## Solicitation Addendum

**Addendum No.:** 3  
**Solicitation No.:** 19-TA003062AJ  
**Project No.:** 6092080 & 6092180  
**Solicitation Title:** SEWRF RAS / WAS Upgrade and Plant Drain Pump Stations Projects  
**Addendum Date:** September 27, 2019  
**Procurement Contact:** Abigail Jenkins

**EMBEDMENTS FOR CONDUITS**

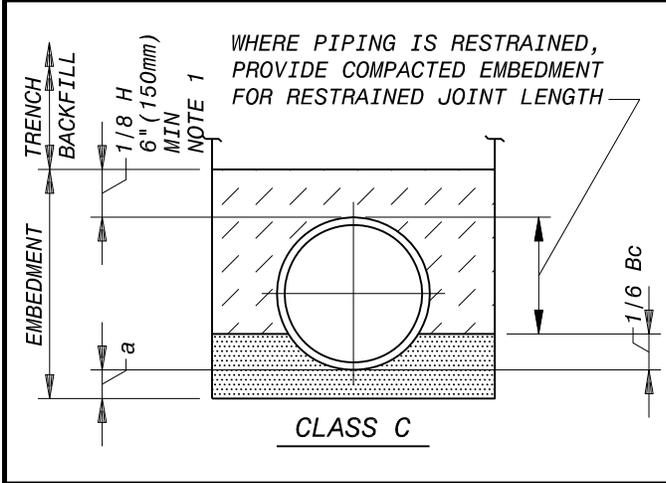
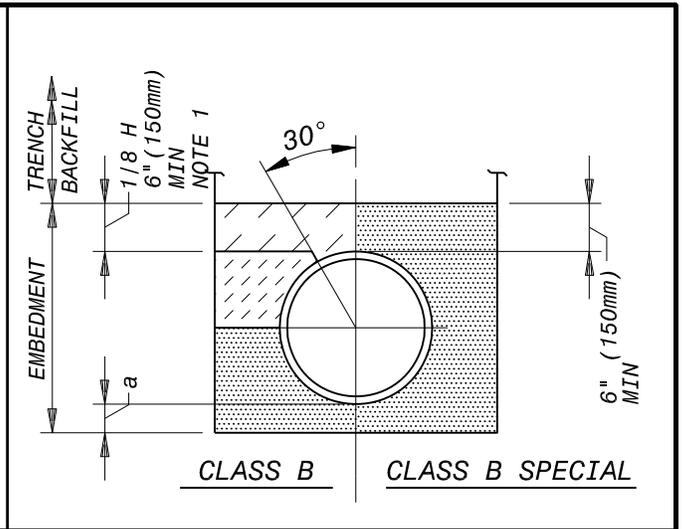
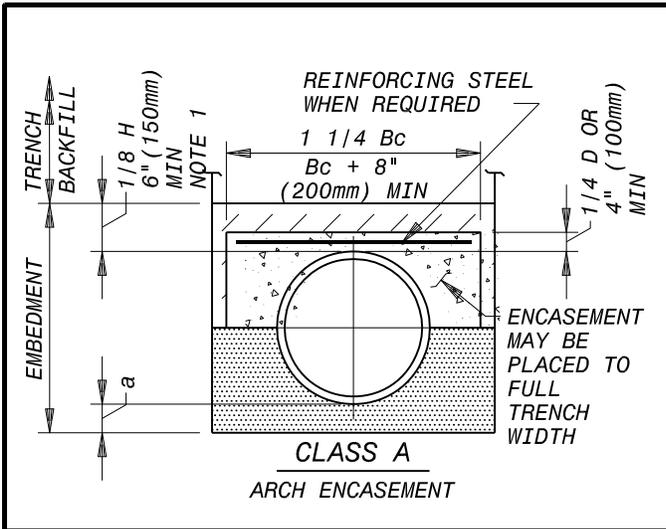
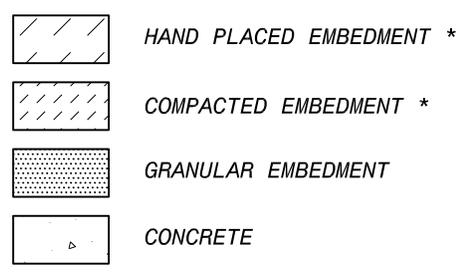
**Q31. Reference specification section 02202 Trenching and Backfilling 3-4. Pipe Embedment. Unable to locate Figure 1-02202 referenced in this section?**

**Q32. Reference specification section 02202 Trenching and Backfilling 3-4. Pipe Embedment. Please confirm that CLSM is to be used for embedment of the 16" pipe from NDPS to SDPS. If required can detail be provided.**

R31. See Attachment 7, Fig 02202-F1 Embedment's for Conduit, issued with this Addendum 3.

R32. In accordance with Specification 02202, Section 3-4, CLSM shall be used for embedment for the 16" pipe. Refer to Figure 1-02202 for detail.

ADD BOTH DETAILS BELOW TO E-16 (RAS/WAS PROJECT) AND E-13 (PDPS PROJECT)

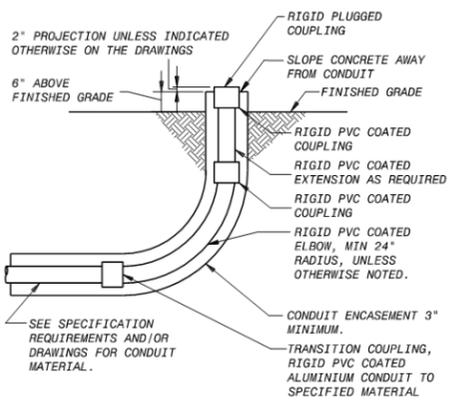
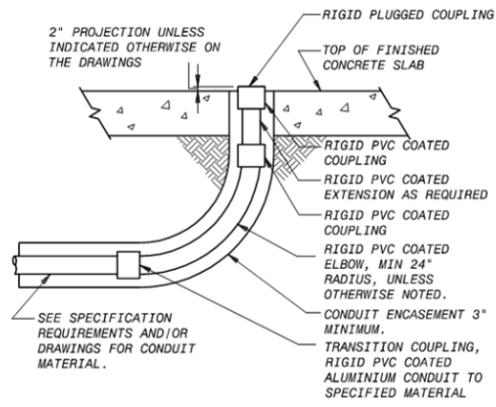
**Q16. Please review and confirm that the following specification section is correct: Specification Section 16050 3-7.01 c. Conduit installed in all exposed outdoor locations shall be rigid aluminum, rigidly supported by stainless steel framing materials. Mounting hardware, which includes nuts, bolts, and anchors, shall be stainless steel. All damaged coatings shall be repaired according to the manufacturer's instructions. I believe this should read “shall be PVC coated rigid aluminum”.**

R16. The PVC-coated aluminum is only used for underground transition to exposed locations per 16050-3-7.01.z. Conduit riser details to be added to the RAS/WAS Project (drawing E-16) and the PDPS Project (drawing E-13). The PVC-coated aluminum is also for non-concrete-encased underground per 16050-3-7.01.e. Exposed conduit in outdoor locations shall be rigid aluminum per 16050-3-.7.01.c.

TYPICAL CONDUIT RISER  
TERMINATING IN SOIL  
NO SCALE

TYPICAL CONDUIT RISER  
TERMINATING IN CONCRETE SLAB  
NO SCALE
